Product Change Notification: PCN-23-179535

ASSEMBLY BATTERY CONNECTOR, SURFACE MOUNT, TOP LOAD

Adjust package tape structure.

Difference for existing and new package

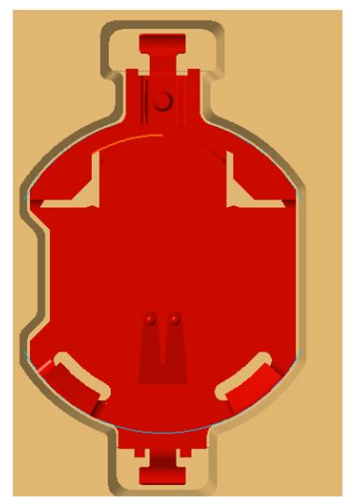
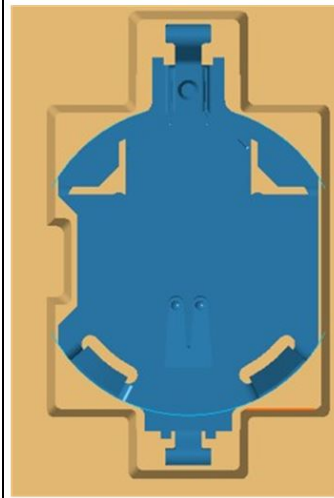
Now

Future
